Special Use Permit #2024-00041
404-A East Alexandria Avenue

Application	General Data	
Public Hearing and consideration of requests for Special Use Permits to construct a single-unit dwelling on a vacant substandard lot and for a lot without frontage on a public street	Planning Commission Hearing:	November 7, 2024
	City Council Hearing:	November 16, 2024
Address: 404-A East Alexandria Avenue	Zone:	R-2-5/ Residential
Applicant: Eric Teran and Daniela Gross	Small Area Plan:	Potomac West

Staff Recommendation: APPROVAL subject to compliance with all applicable codes, ordinances, and the recommended permit conditions found in Section III of this report.

ORIGINAL SUP DESIGN

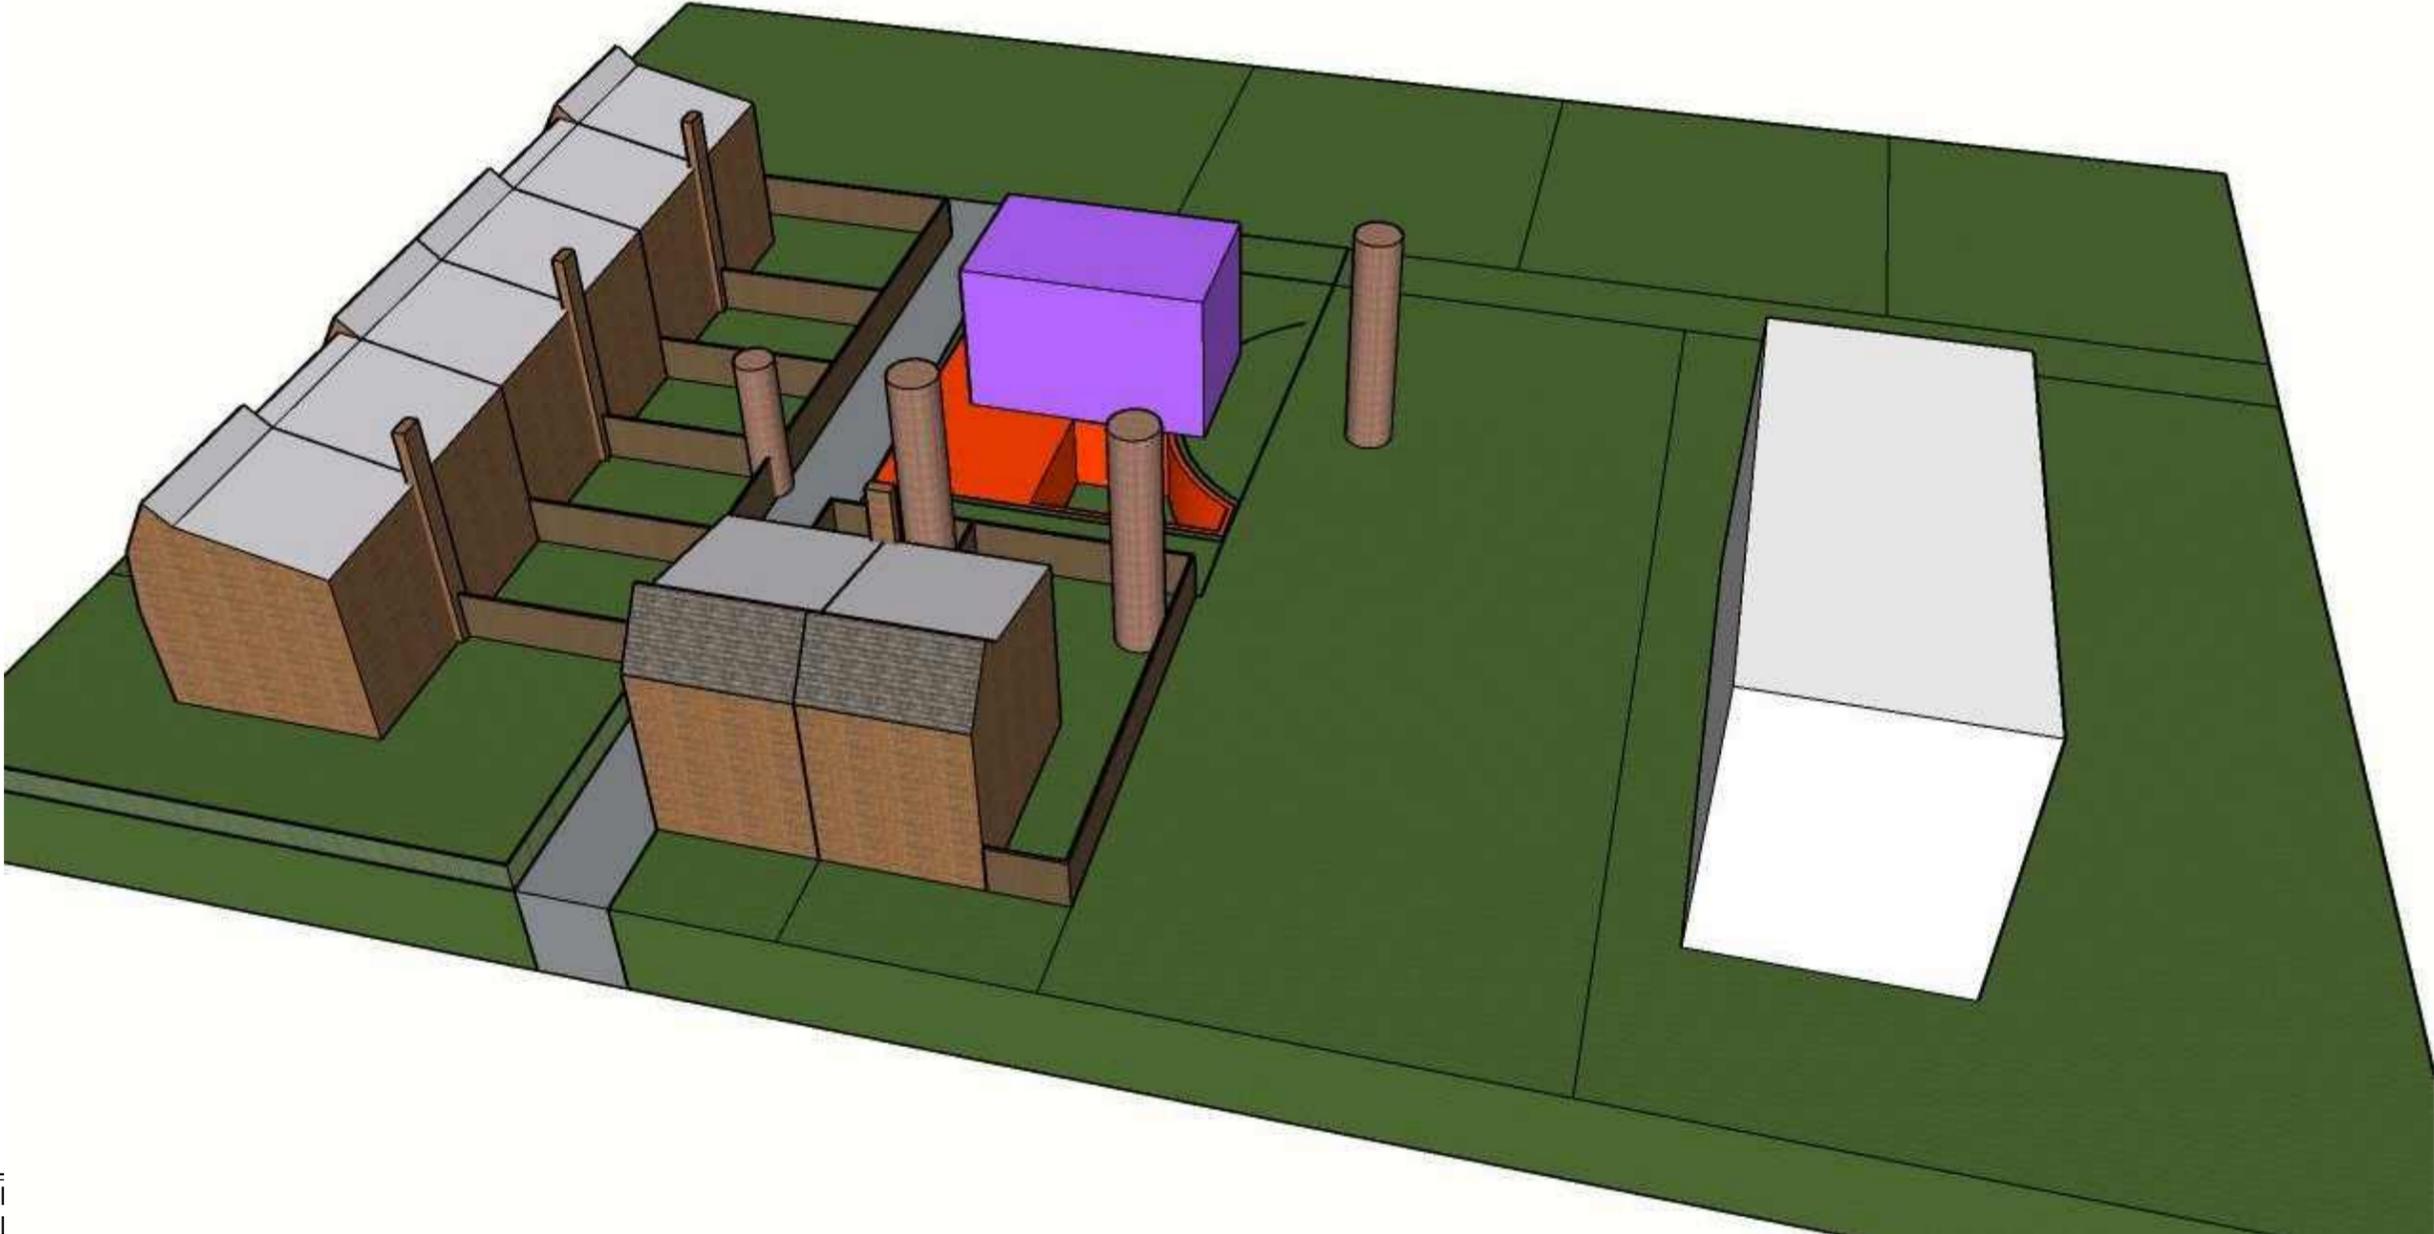
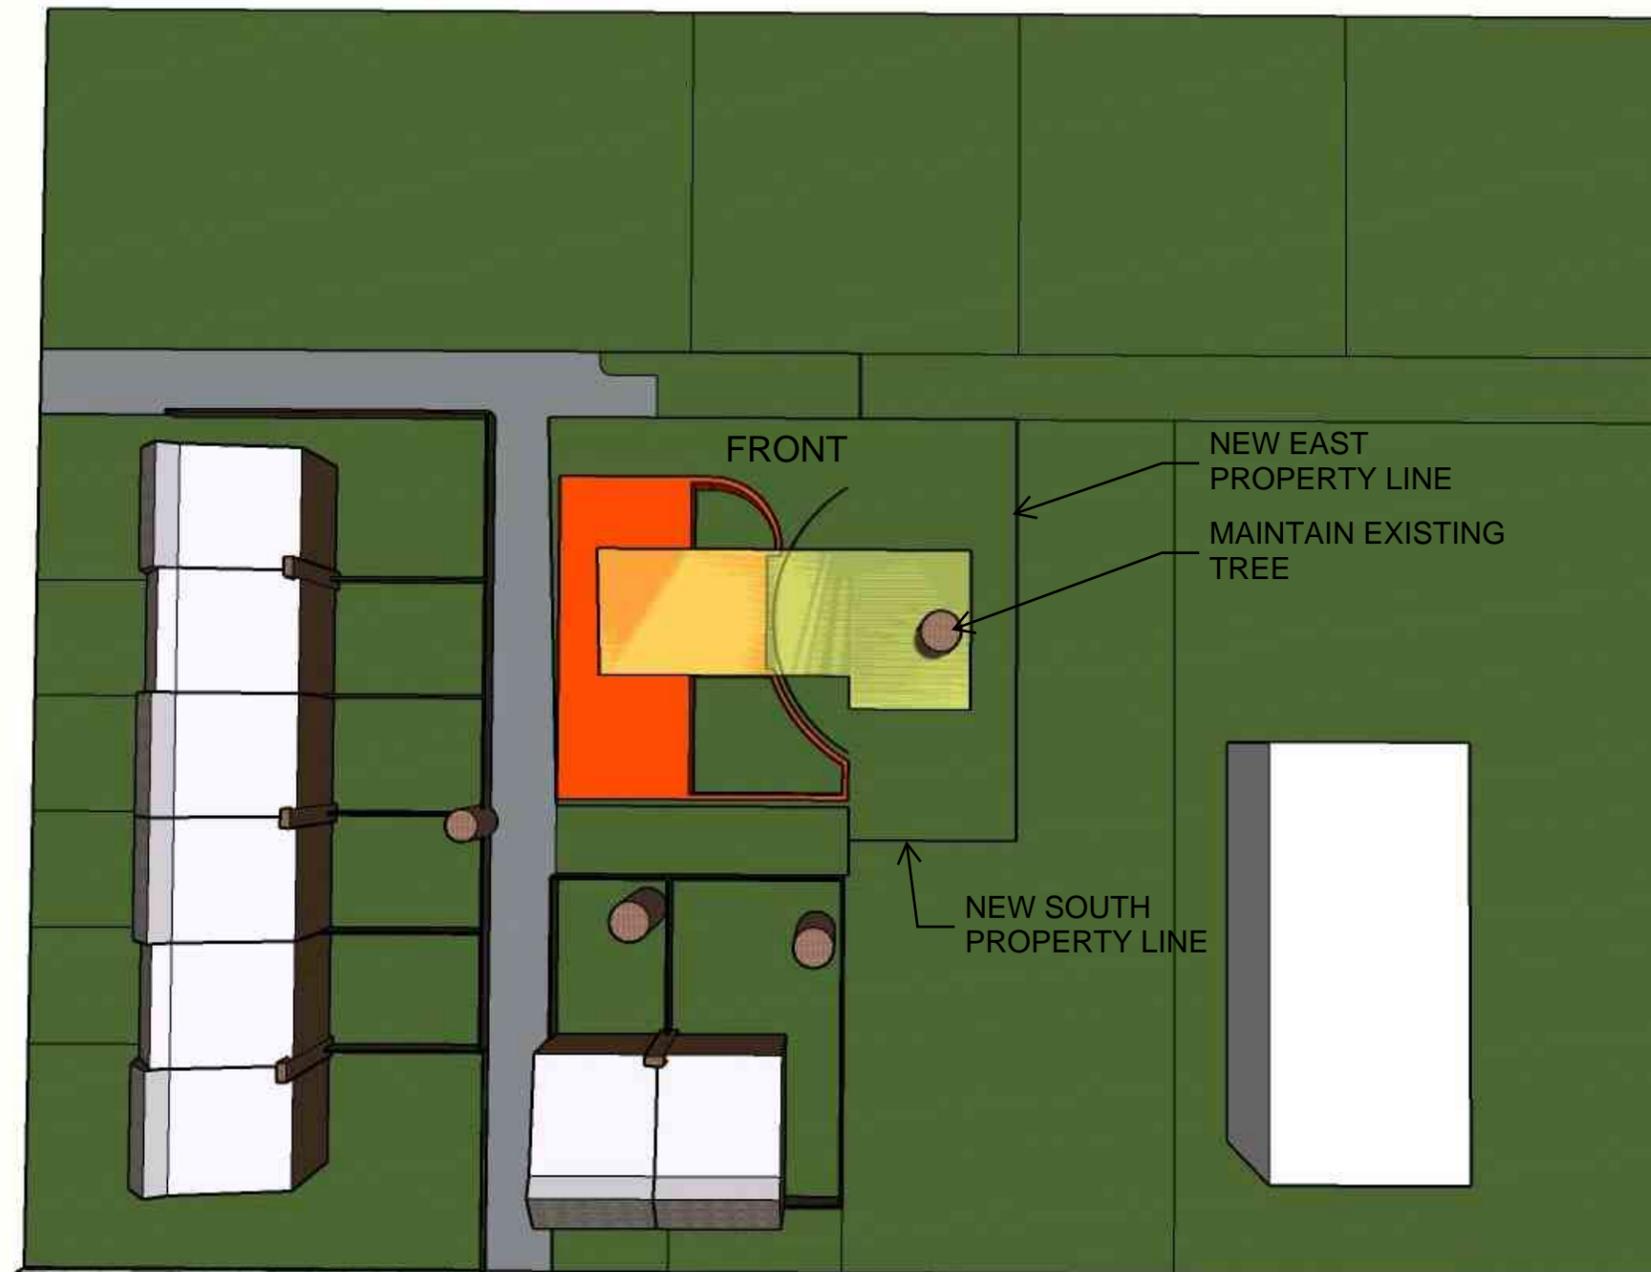
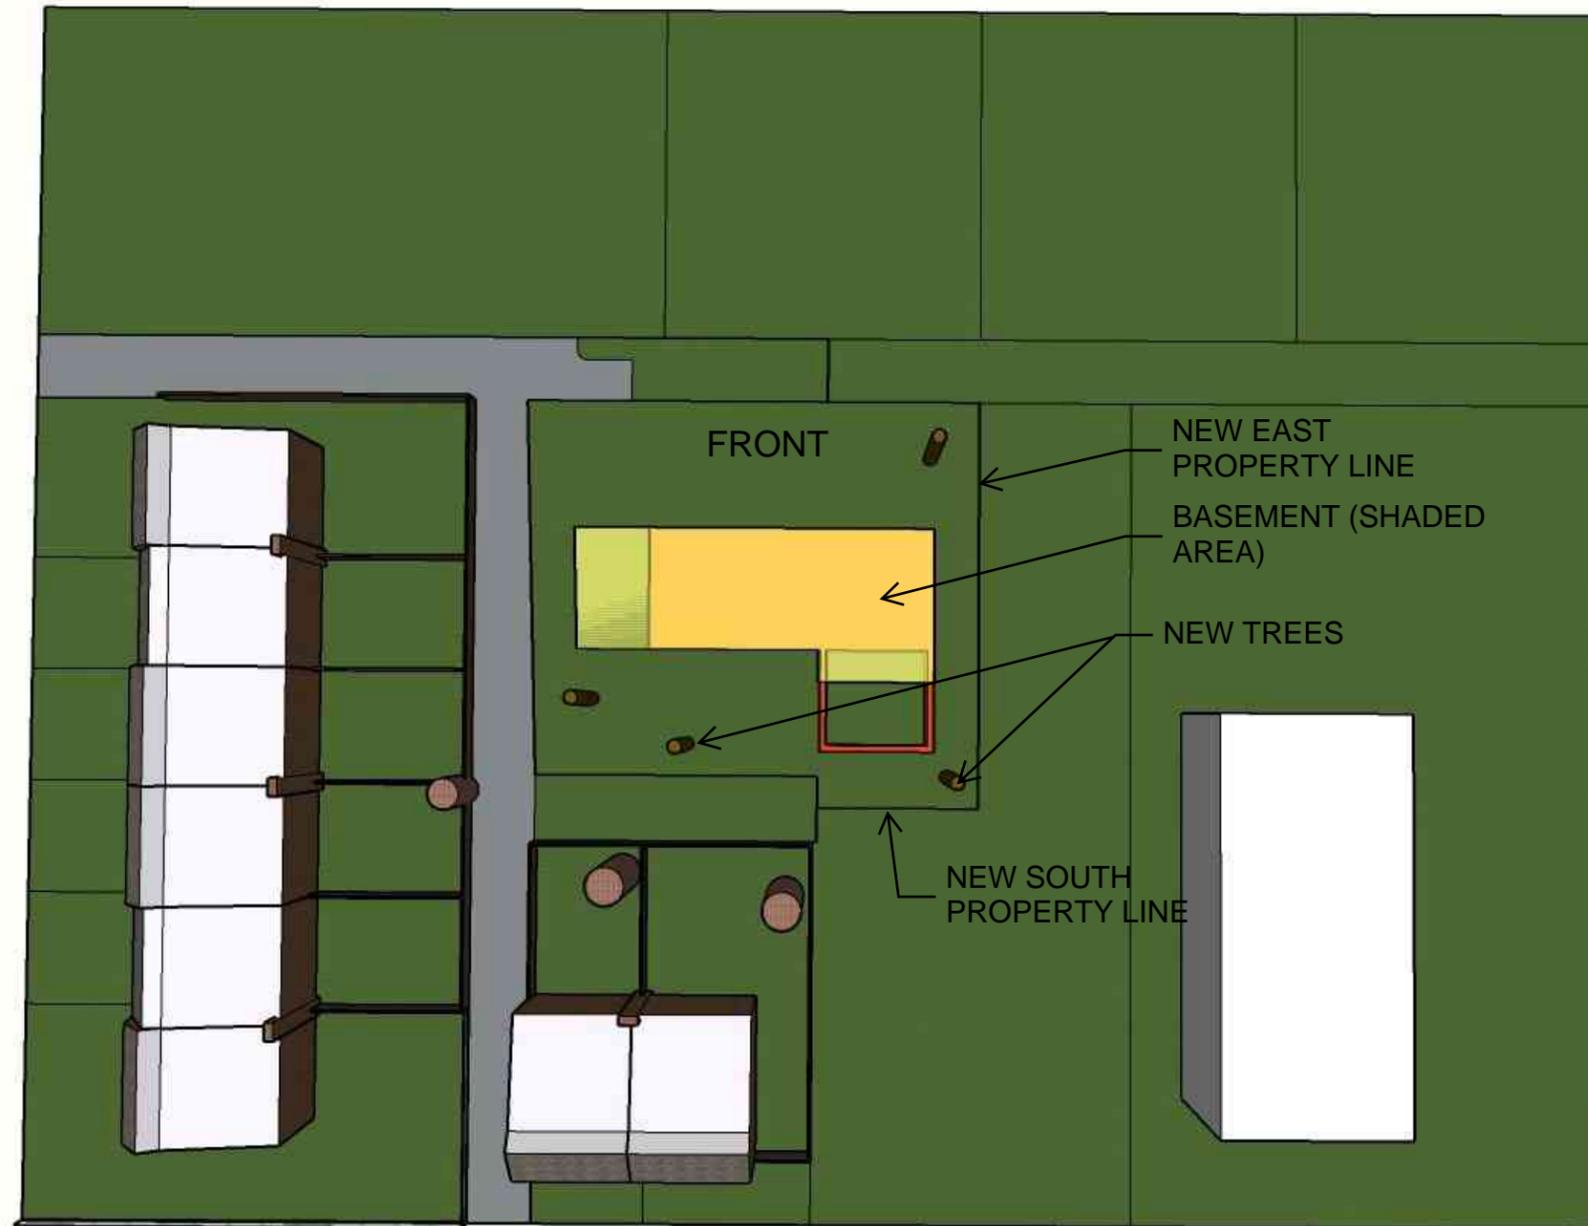
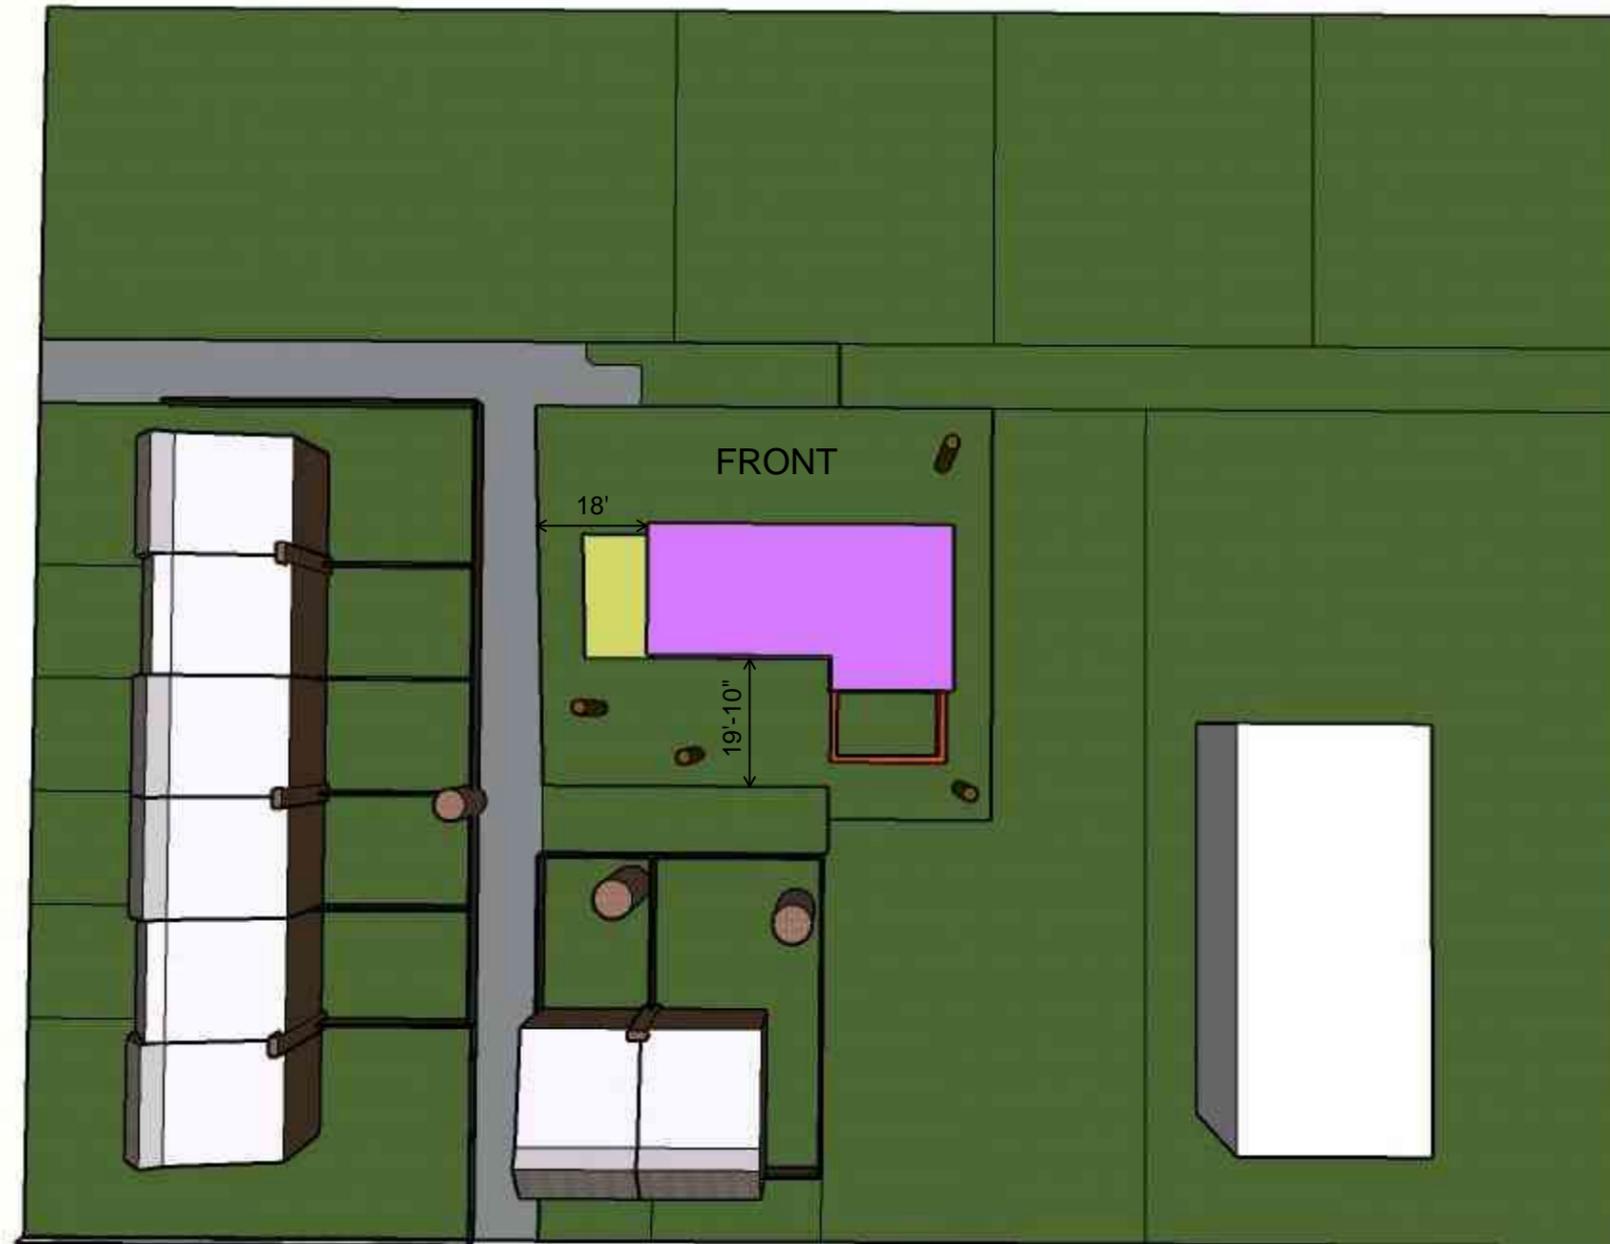
1. NEW LOT SIZE PER APPROVED VACATION REQUEST
2. MAINTAIN ORIGINAL BASEMENT DESIGN
3. PROTECT EX. SILVER MAPLE TREE

1. REMOVE THE SILVER MAPLE TREE AND PLANT 3 - 4 NEW TREES

2. THE BASEMENT IS RECONFIGURED AND CONTAINED WITHIN THE ABOVE GRADE BUILDABLE AREA.

1. THE ABOVE GRADE FLOORS ARE SHIFTED TO THE EAST PROVIDING A SETBACK OF 18'-0" FROM THE ALLEY. THE ORIGINAL DESIGN IS 7'-0".

1. THE HOUSE IS MORE VISIBLE FROM E. ALEXANDRIA AVE.

1. THE FRONT YARD IS ON THE WEST SIDE OF THE PROPERTY CREATING A DIFFERENT BUILDABLE AREA
2. REMOVE THE SILVER MAPLE TREE AND PLANT 3 - 4 NEW TREES
3. THE BASEMENT IS RECONFIGURED AND CONTAINED WITHIN THE ABOVE GRADE BUILDABLE AREA.

2. THE SOUTH FACADE IS NOW ONLY 9'-0" FROM THE PROPERTY LINE COMPARED TO 19'-10" IN THE ORIGINAL DESIGN.

3. THE "L" SHAPE PROVIDES LESS VISIBILITY FROM E. ALEXANDRIA AVE.

1. THE "L" SHAPE AND VEGETATION PROVIDES LESS VISIBILITY FROM E. ALEXANDRIA AVE.
